From: Dennis M. Postler <dennis.postler@tkda.com>
Sent: Thursday, June 18, 2020 2:49 PM
To: Elizabeth Mursko <cityadministrator@ci.columbus.mn.us>; Jim Windingstad <jwsuperintendent@ci.columbus.mn.us>
Cc: Larry Poppler <larry.poppler@tkda.com>
Subject: FW: N.698146 / MNCL19.80163E_Hornsby St Realignment-Columbus

**HORNSBY STREET
 NORTH REALIGNMENT**

DRAINAGE PLAN AND PROFILE
 TH 97 STA. 417+83.82 TO STA. 433+00

CONSTRUCTION PLAN

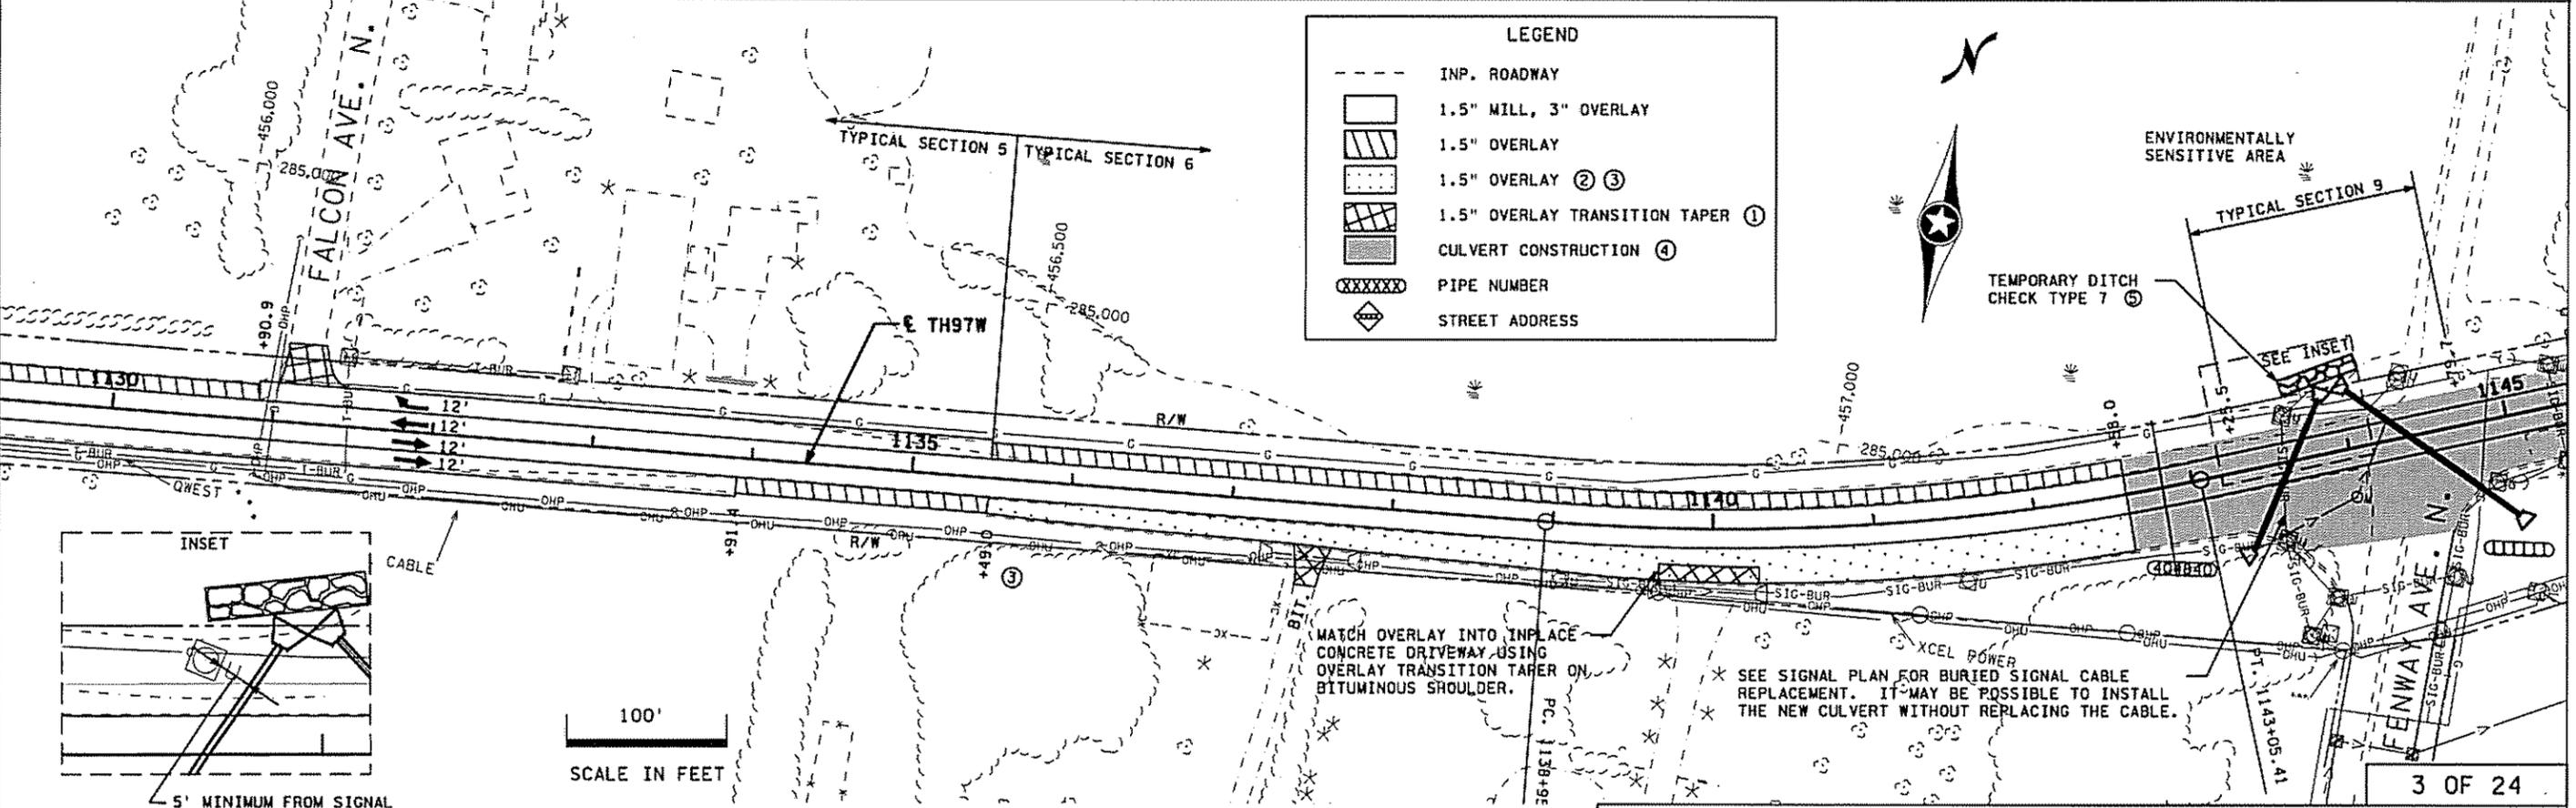
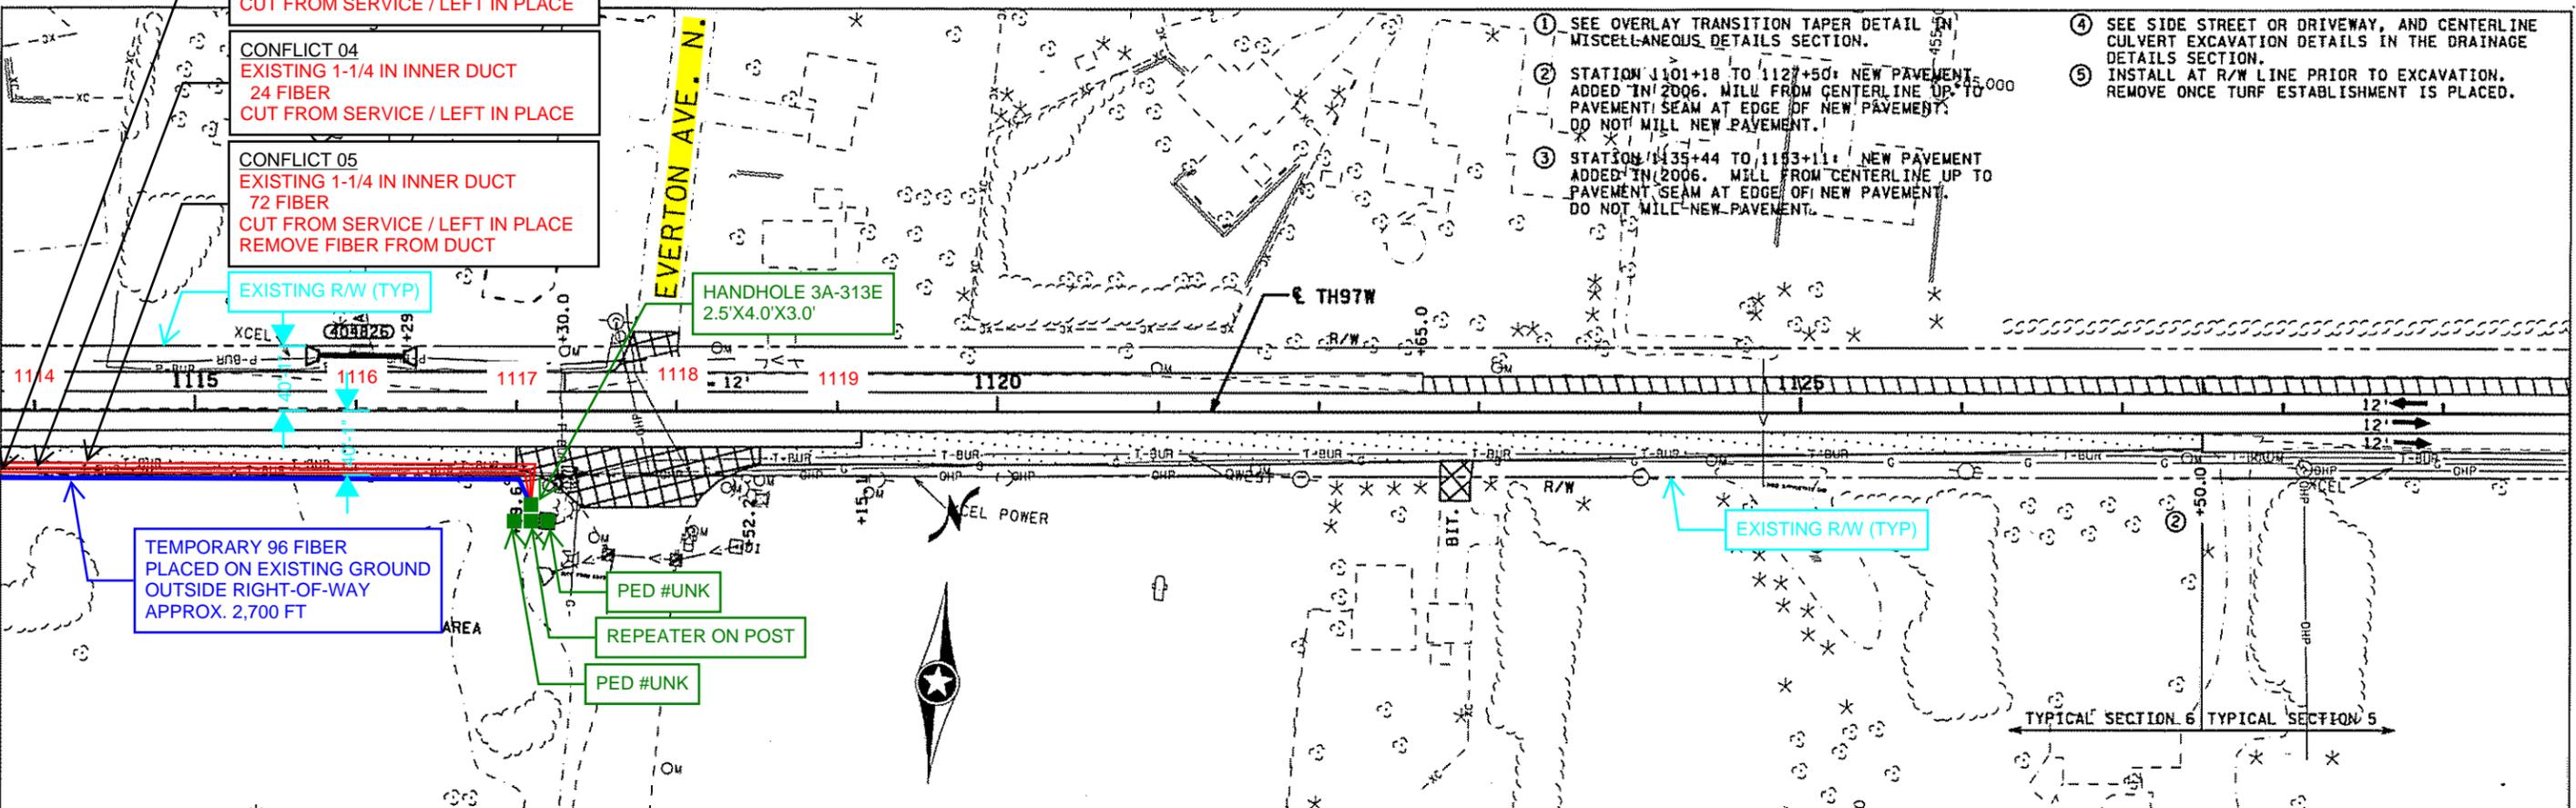
- CONFLICT 03
EXISTING 400 PAIR
CUT FROM SERVICE / LEFT IN PLACE
- CONFLICT 04
EXISTING 1-1/4 IN INNER DUCT
24 FIBER
CUT FROM SERVICE / LEFT IN PLACE
- CONFLICT 05
EXISTING 1-1/4 IN INNER DUCT
72 FIBER
CUT FROM SERVICE / LEFT IN PLACE
REMOVE FIBER FROM DUCT
